An Coimisiún um Rialáil Fónais
Commission for Regulation of Utilities

Post-ORESS1 Material Change Review

EirGrid Phase 1 Offshore Wind General & Functional Specifications

Reference:	CRU/2025/162	Date Published:	14/10/2025
-------------------	--------------	------------------------	------------

Figure 1 CRU simplified depiction of EirGrid change to OFD-OSP-504 Point of Connection

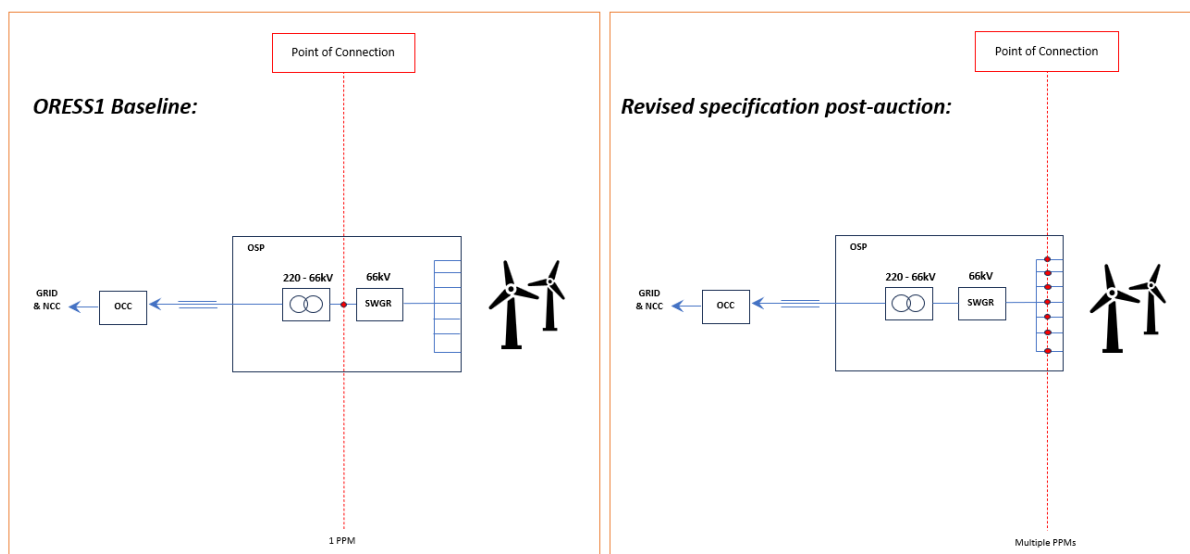
In Drawing OFD-OSP-504 Revision R1, EirGrid proposes to change the offshore 66kV Point of Connection (PoC) from the Offshore Substation Platform (OSP) Power Transformer (66kV side) to the 66kV String/Cable Ends (i.e. smaller Power Park Module (PPMs)) to (1) Establish a clear asset ownership boundary; (2) To avoid and/or minimise the impact of inadvertent and/or uncontrolled offshore 66kV switching on the Irish network; (3) To ensure full compliance with the metering code requirements; (4) To restrict uncontrolled access onto the OSP by Third Parties, and (5) To establish a consistent approach to implementing the site safety rules and arrangements.

EirGrid asserts that the change of 66kV PoC will result in smaller more manageable offshore PPMs, and EirGrid believes it will be easier to progressively ramp-up power and integrate the Phase 1 Projects onto the Irish grid. However, the CRU notes that this represents a major change from the pre ORESS1 position, and it is likely to lead to higher Phase 1 Project CAPEX and OPEX costs. Furthermore, EirGrid's MCR change has not taken into consideration the impact of delayed commissioning, higher costs, and delay to commercial operation dates and losses of revenue for the Phase 1 Developers.

However, the CRU considers based on a review of the MCR submission that the implementation of EirGrid's offshore 66kV PoC change introduces potentially substantial additional CAPEX for Phase 1 projects. This includes requirements for additional metering infrastructure, SCADA systems, modifications to OSP deck and modules, cross-boundary switching, and increased commissioning resources potentially escalating the levels of intervention and resources needed by all parties. Furthermore, the Phase 1 Developers would be required to register each PPM (as per Grid Code for Generators), and the magnitude of cost and/or timescale risks is likely to give rise to bankability issues at FID. Moreover, the deployment of smaller offshore PPMs may result in considerable delays during the commissioning phase and risk movements to the Commercial Operation Date (COD) and thereby lead to potentially significant losses in operational revenue.

EirGrid, in its MCR submission, has stated that its revised approach aligns closely with practices adopted by other European TSOs in Belgium, Germany, and the Netherlands. However, EirGrid was unable to provide specific project references or provide documented evidence to demonstrate and confirm that the 66kV strings are being used as the offshore designated PoC and "De facto Standard" in those jurisdictions. On this specific aspect, and given its importance, the CRU sought further clarifications and requested specific examples, including company/project references. EirGrid provided no additional information to satisfy this request.

1. EirGrid’s references within the MCR submission to other European TSOs and claims that “66kV strings are becoming the ‘de facto’ standard for most European projects” were found to be insufficient. Despite the CRU’s request for further clarification, including specific company and project references to substantiate this position, EirGrid provided limited supporting evidence. As a result, the MCR submission lacks the necessary technical justification to validate the proposed change,

3. The 66kV offshore point of connection consultation is yet to be concluded and EirGrid has yet to respond to the “Alternate Proposed Solution” provided collectively by the Phase 1 Developers issued in February 2024. CRU notes that the MCR process has temporarily suspended progress on this particular change (From April 2025),
4. The CRU remains uncertain as to the status and outcome of Grid Code Modification MPID 305 entitled “Offshore PPM’s” and the corresponding actions relating to the connection point, and
5. The CRU also notes that the ORESS1 position aligns with the definitions contained in Grid Code Version 15.

Additionally, the CRU considers that in rejecting the current proposal from EirGrid and resetting the offshore 66kV PoC back to the ORESS1 baseline will provide a clear path and starting point for EirGrid and the Phase 1 projects to re-engage in proactive technical discussions to derive an acceptable outcome; and whereby the “Alternate Proposed Solution” (February 2024) and references to other European TSO projects can be relied upon to underpin and support specification/drawing finalisation.
